Chapter 2 Comments and Responses on the Jepson Parkway Project

Letter 1
FEMA

This is in response to your request for comments on the Jepson Parkway Project Draft Environmental Impact Report/Environmental Impact Statement and Draft Section 4 (f) Evaluation dated May 2008.

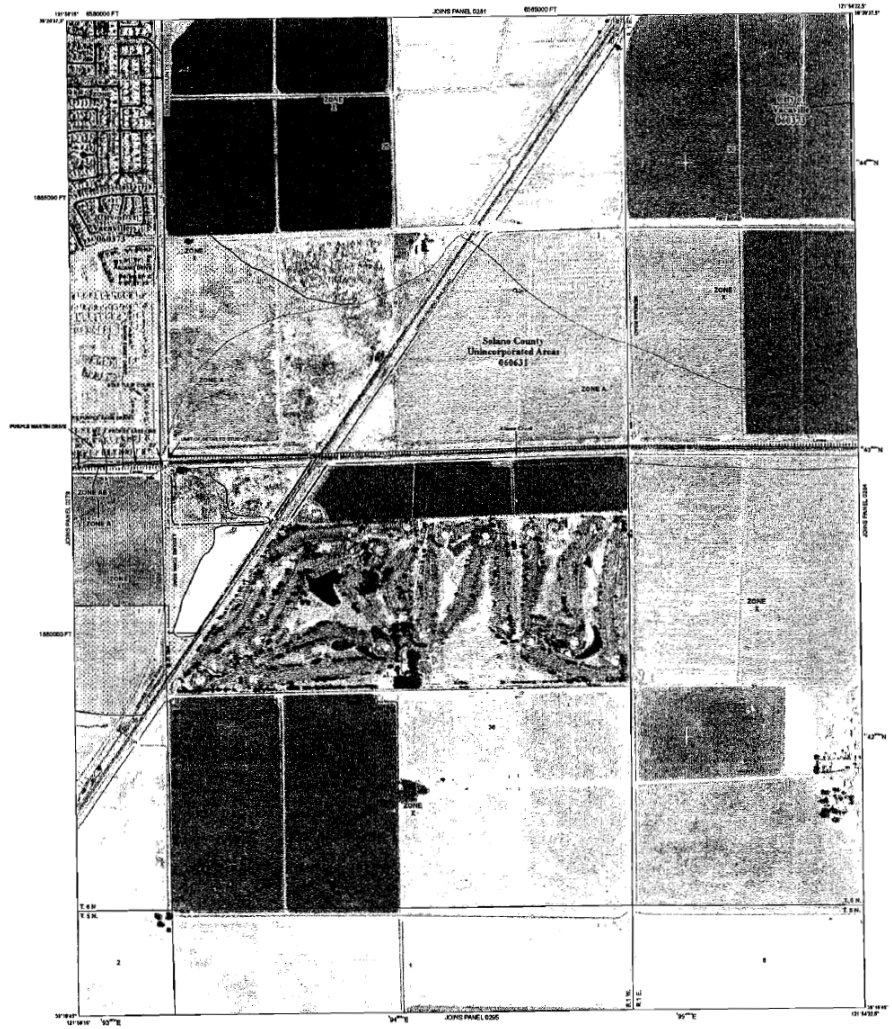
The Flood Insurance Rate Maps for Solano County are currently being revised. The Special Flood Hazard Area (SFHA) is anticipated to expand at the intersection of New Alamo Creek and Leisure Tow Road as shown on the attached preliminary panel, 06095C0283E. This expansion has the potential to impact your project as shown of Figure 3.9-3 of your report. 1-1

1-1. Thank you for the comment. The Special Flood Hazard Area for this area will be reviewed and accounted for during the final design phase of the project. A detailed hydraulic analysis of New Alamo Creek will be completed as part of the final design.
